To: Gregory P. Bernard, Wenham Health Agent
From: Charles G. Johnson, P.E. (Civil) *CET*
Date: April 22, 2015
Re: Proposed On-Site Wastewater Treatment & Dispersal System Plan

Site: Proposed "Maple Woods" at 62 Maple Street (Tax Map 23, Lot 16)

**Re: On-Site Wastewater Treatment and Dispersal System for "Maple Woods"
Response to Wenham Board of Health Plan Review Letter**

RE: Peer Review for Maple Woods Wastewater Treatment System
Comprehensive Permit Application

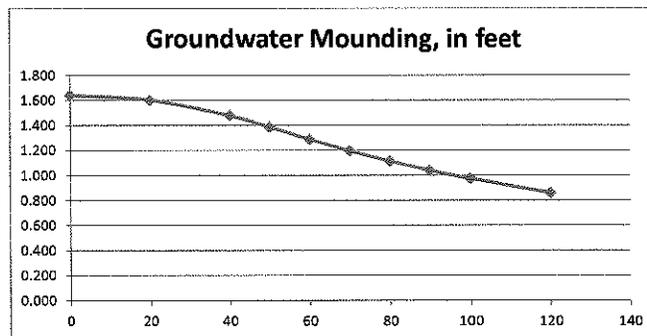
Comment #6: In the groundwater mounding calculations on Sheet 2, the Applicant uses a Specific Yield (Sy) of 0.25 and duration of infiltration period (time) of 90 days, which meets MassDEP requirements. However, in our opinion a longer time period and lower specific yield would better represent a steady state condition. Additionally, the Applicant assumes a saturated thickness depth equal to elevation 40.8, (a total aquifer thickness of 13.8 feet), which is described as elevations in the wetlands. The test pit data does not show the loamy fine sand or loamy medium sand material extending beyond elevation 46.7. HW recommends conducting a soil boring in the location of the leaching field to verify the saturated thickness of the loamy fine sand and loamy medium sand material.

Response #6: The groundwater mounding calculations were reviewed with Mr. H. Criss Stephens, Jr. (Hydrogeologist at the Northeast Regional Office of Mass DEP in Wilmington, MA), and he prepared the attached e-mail dated April 16, 2015. The initial saturated thickness (hi) value on Sheet 2 was changed from 13.8 feet to 7.9 feet (54.6 – 46.7). The groundwater mounding adjustment changed from 1.1 feet to 1.6 feet and is included as an attachment. Since Mr. Stephens agreed with the methodology presented on the design plans, using a longer time period and lower specific yield will not be necessary. Also, conducting a soil boring in the location of the leaching field will not be necessary.

- Recharge rate (R) = 0.098 feet/day,
- Specific yield (S_y) = 0.25,
- Horizontal hydraulic conductivity (K_h) = 25 feet/day,
- SAS length = 100 feet,
- SAS width = 90 feet,
- Duration of infiltration(t) = 90 days,
- Initial saturated thickness (h_i) =7.9 feet.

The resultant output yields a groundwater mound of 1.6 feet.
